TX/RX Frequency expansion of IC-7700

Author: Icom

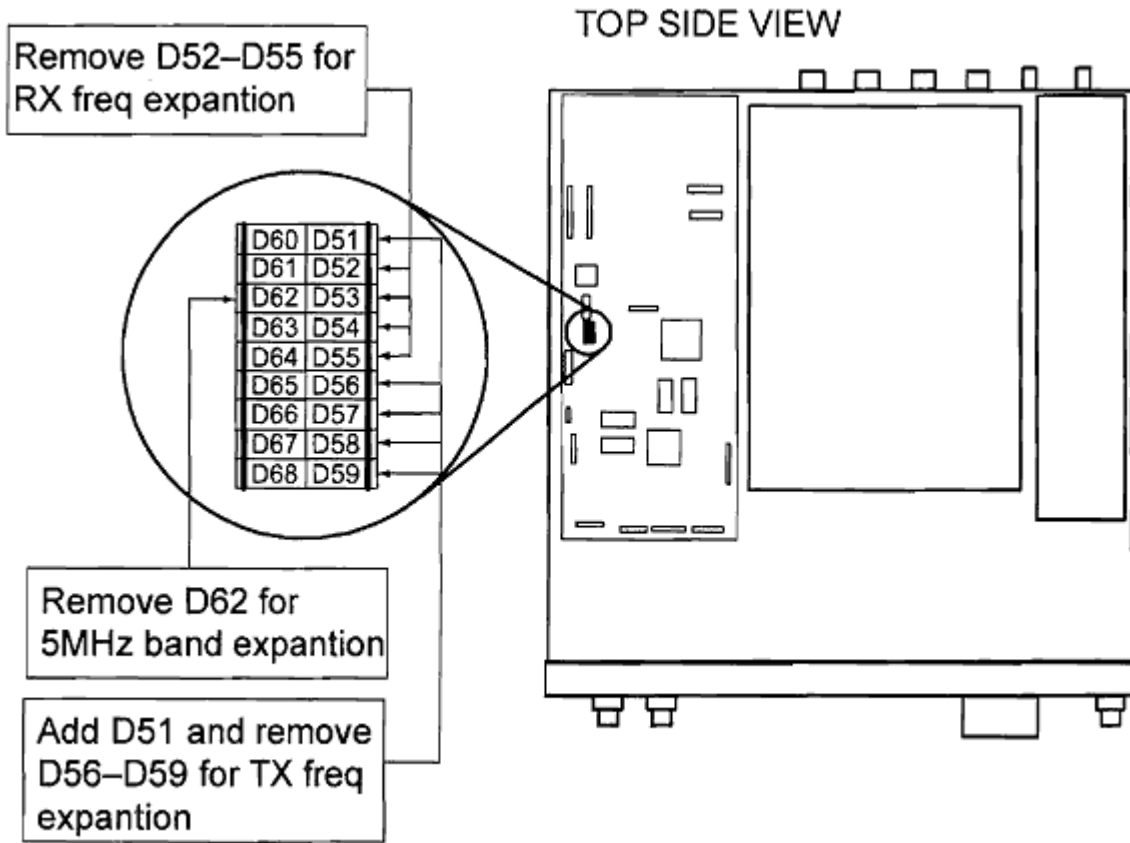
Remove D52, D53, D54 and D55 as shown below.

Add D51 and remove D56, D57, D58 and D59 as shown below.

Remove D62 as shown below.

Expanded "frequency:

HF band: 1.6-29.999999 MHz, 50MHz band: 51-54 MHz

Expanded frequency: 5.255-5.405 MHz
